**CITY OF VAUGHAN**

**EXTRACT FROM COUNCIL MEETING MINUTES OF FEBRUARY 18, 2014**

**ZONING BY-LAW AMENDMENT FILE Z.12.020  
DRAFT PLAN OF SUBDIVISION FILE 19T-12V002  
MAPLEQUEST (VAUGHAN) DEVELOPMENTS INC.  
WARD 3 – VICINITY OF WESTON ROAD AND MAJOR MACKENZIE DRIVE**

**DATE:** FEBRUARY 14, 2014  
**TO:** HONOURABLE MAYOR & MEMBERS OF COUNCIL  
**FROM:** JOHN MACKENZIE, COMMISSIONER OF PLANNING  
**RE:** COMMUNICATION - COUNCIL MEETING - FEBRUARY 18, 2014  
ITEM #10, COMMITTEE OF THE WHOLE - FEBRUARY 4, 2014

Revised Attachment #3 - Revised Location Plan

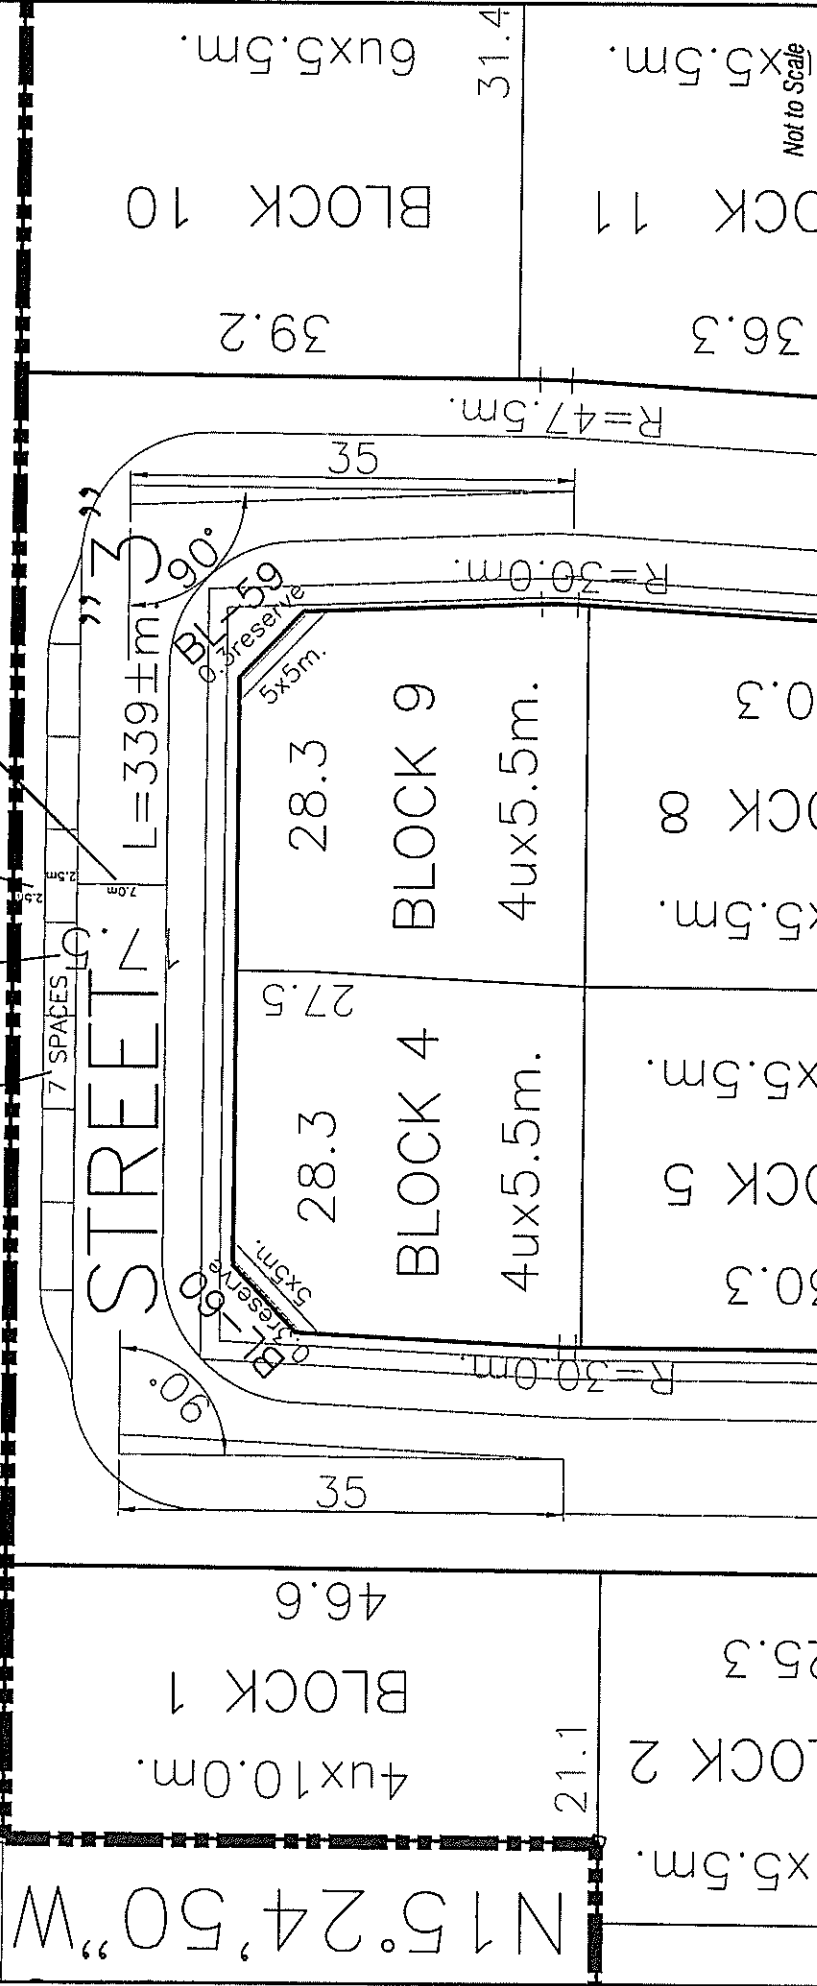
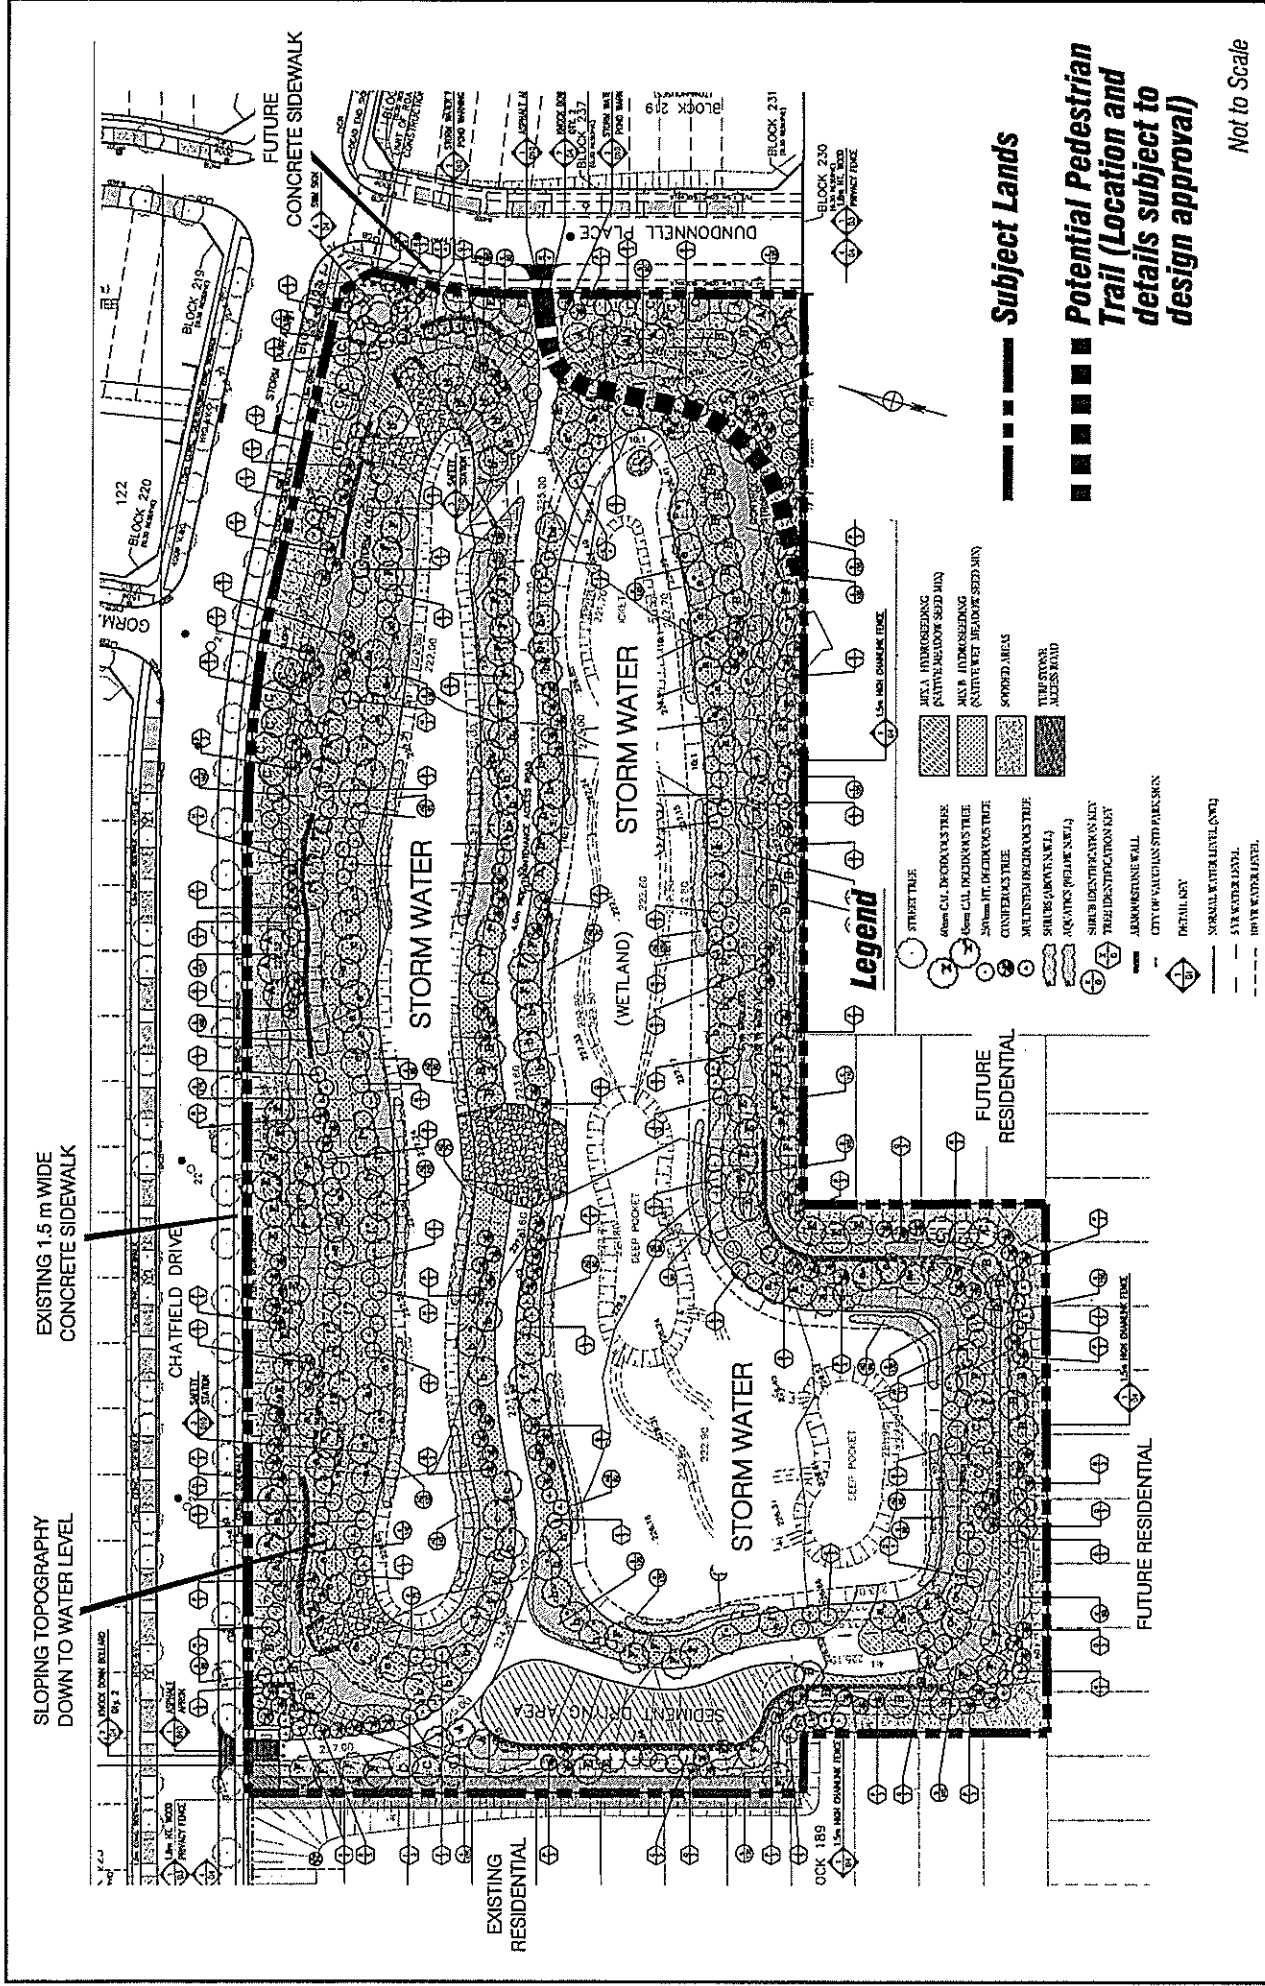
- a) modify the width of the east-west extension of Street "3" from a 17.5 m wide local road to a 15 m wide single-loaded road, in order to accommodate lay-by parking spaces within the remaining 2.5 m width adjacent to the stormwater management facility (Block 193, Registered Plan 65M-4145); and,

- b) include a 6 m wide right-of-way for a pedestrian trail from the Draft Plan of Subdivision into and through the stormwater management facility lands (Block 193, Registered Plan 65M-4145)."

MODIFY 17.5 m WIDE LOCAL ROAD  
TO 15 m WIDE SINGLE - LOADED ROAD

7 LAY - BY PARKING SPACES  
(2.5 m DEPTH - 6.7 m WIDTH)

4 m WIDE BOULEVARD  
MODIFIED TO 2.5 m WIDE  
BOULEVARD

adjacent to the stormwater management facility lands (Block 193, Registered Plan 65M-4145), as shown on Revised Attachment #3 to this Communication. Street "3" within Draft Plan of Subdivision 19T-12V002 is designed as a local 17.5 m wide road (crescent) that intersects with both Streets "1" and "2" (Revised Attachment #5 to this Communication). The Vaughan Development/Transportation Engineering Department advised that the east-west extension of Street "3" proposes dwelling units only on the south side (Blocks 4 and 9), and thereby is a single-loaded road, which requires a road right-of-way width of 15 m, and not 17.5 m as proposed. Therefore, the 2.5 m that is no longer required for the road right-of-way can be dedicated for lay-by parking.

Accordingly, the road right-of-way width of Street "3" in the Draft Plan of Subdivision can be reduced from 17.5 m to 15 m for the portion of the road that is single-loaded resulting in the remaining 2.5 m of the road right-of-way being dedicated for lay-by parking usage as shown on Attachment #7 to this Communication. Specifically, the 8 m wide pavement is reduced to a 7 m wide pavement and the 4 m wide boulevard is reduced to a 2.5 m wide boulevard. Seven lay-by parking spaces with a width of 2.5 m and a length of 6.7 m can be accommodated within Street "3", as shown on Attachment #7 to this Communication. Recommendations included in this communication to red-line revise the Draft Plan of Subdivision 19T-12V002 and Conditions #1 and #6 in Revised Attachment #1 to this Communication, modify the width of the road right-of-way from 17.5 m to 15 m to accommodate the lay-by parking.
